## ADDENDUM

**ADDENDUM NO.:** 04  
**PROJECT NAME:** Emergency Medical Services (EMS) Addition  
**PROJECT NO.:** 07215  
**CONTRACT NO.:** C1611  
**DATE OF ISSUE:** July 31, 2024

### NOTICE OF CHANGES, MODIFICATIONS, OR CLARIFICATIONS TO CONTRACT DOCUMENTS

7 | 270528 WALL PHONE ROUGH-IN 1G  
NTS

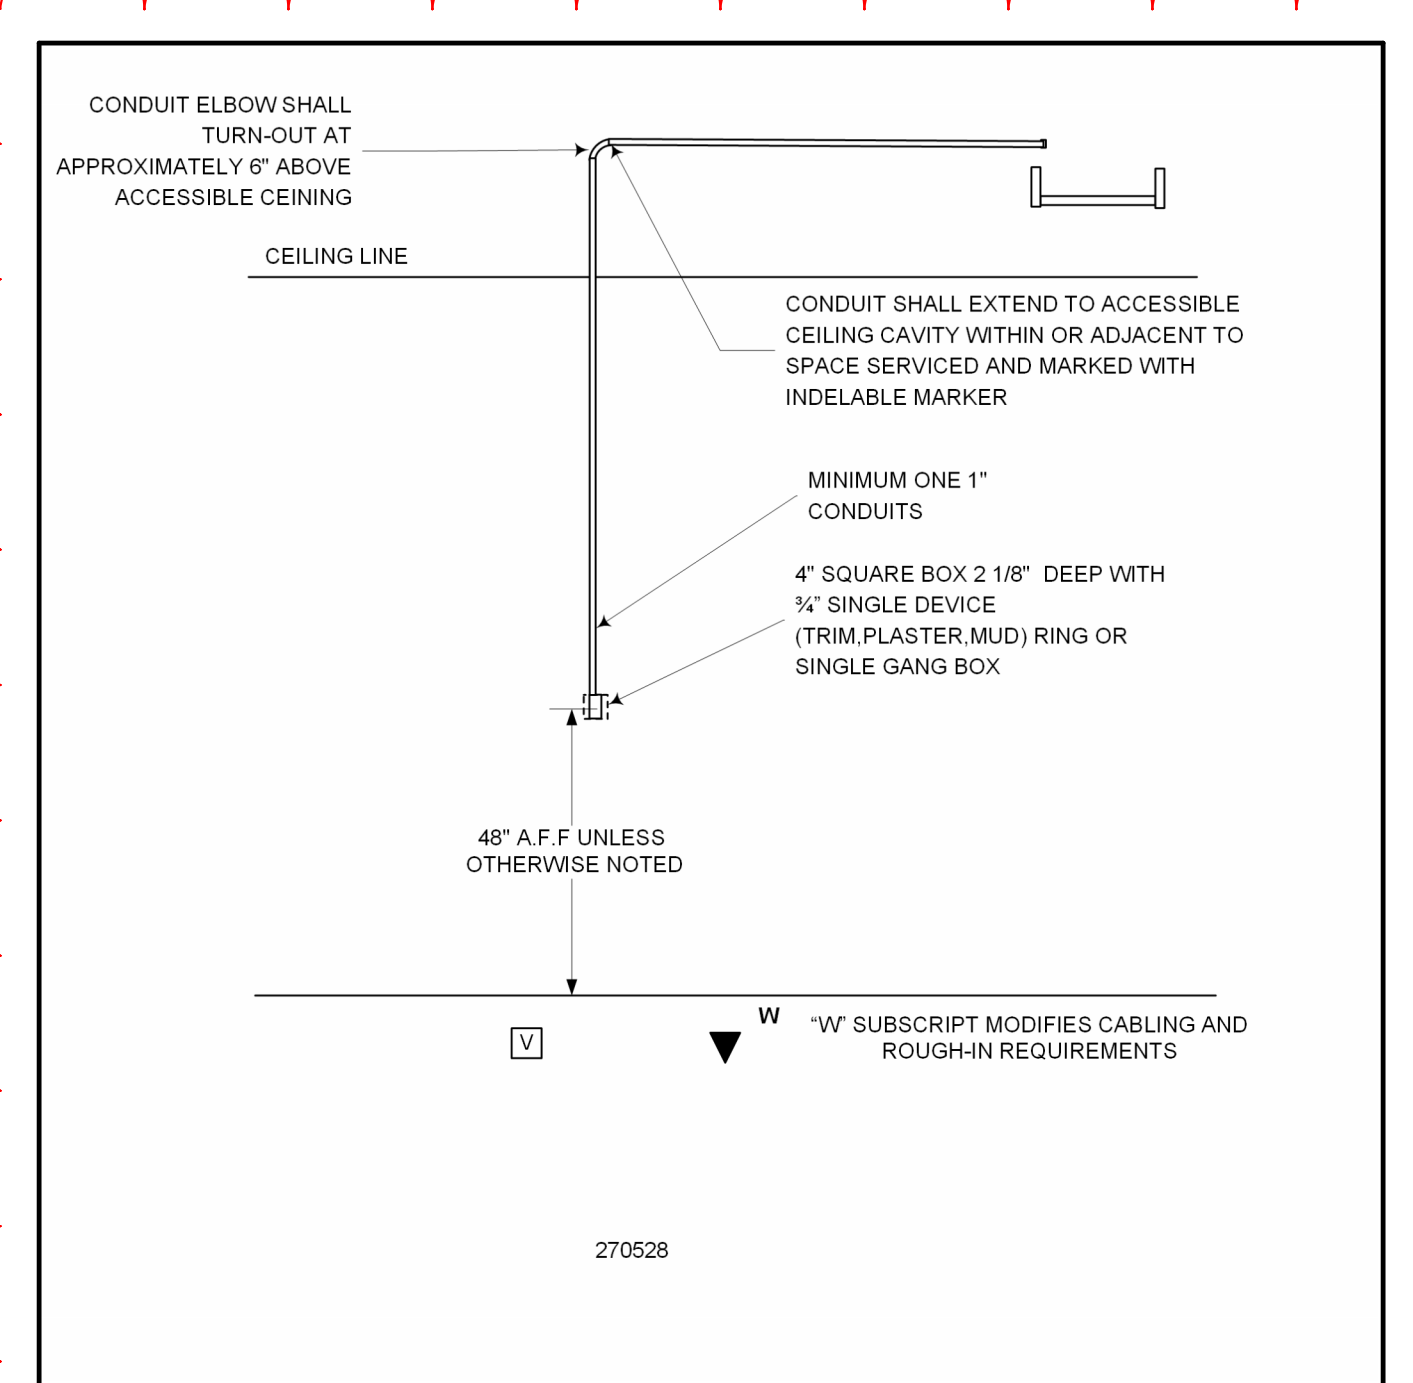
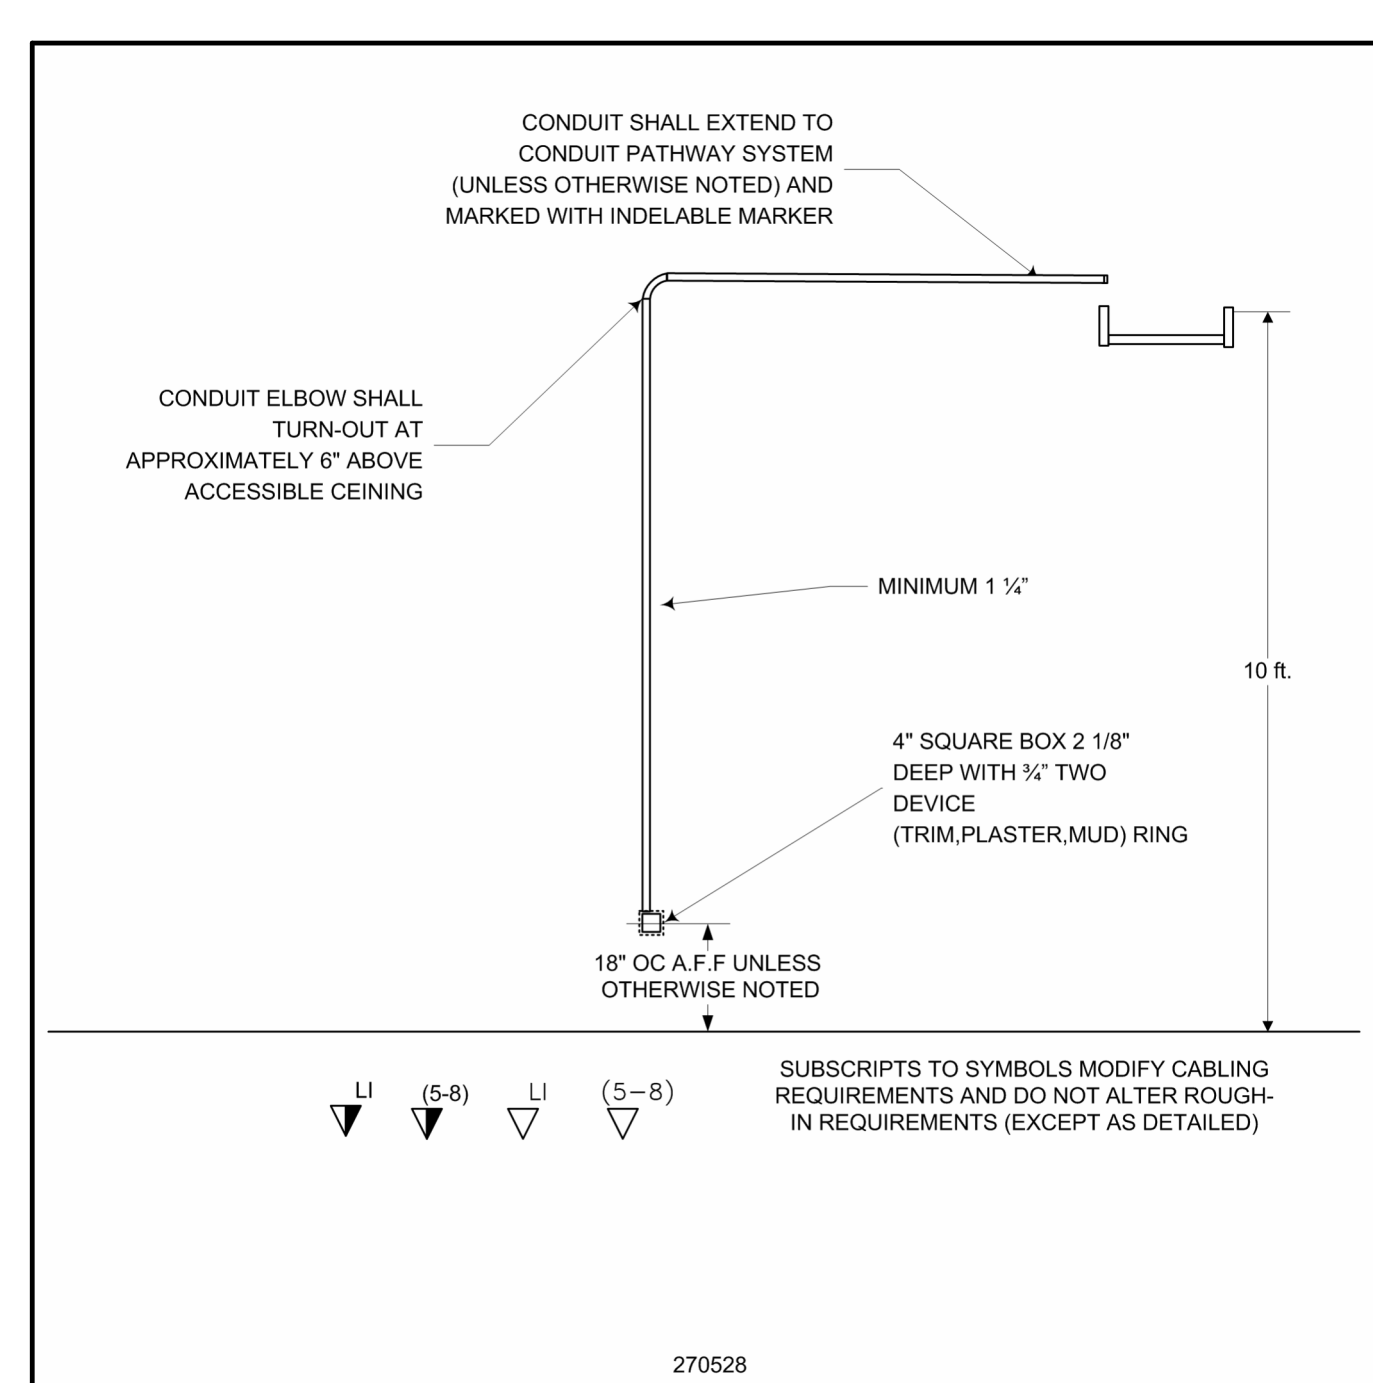
- Change 38 REVISED** Drawing No. T701 – Updated Details 7 & 10.  
**Change 39 REVISED** Drawing No. T702 – Updated Details 3, 4 & 9. Added Detail 10.  
**Change 40 REVISED** Drawing No. T771 – Updated Details 3, 6, 7 & 8.  
**Change 41 REVISED** Drawing No. FA001 – Updated Fire Alarm Riser Diagram to state correct location of existing fire alarm control panel.
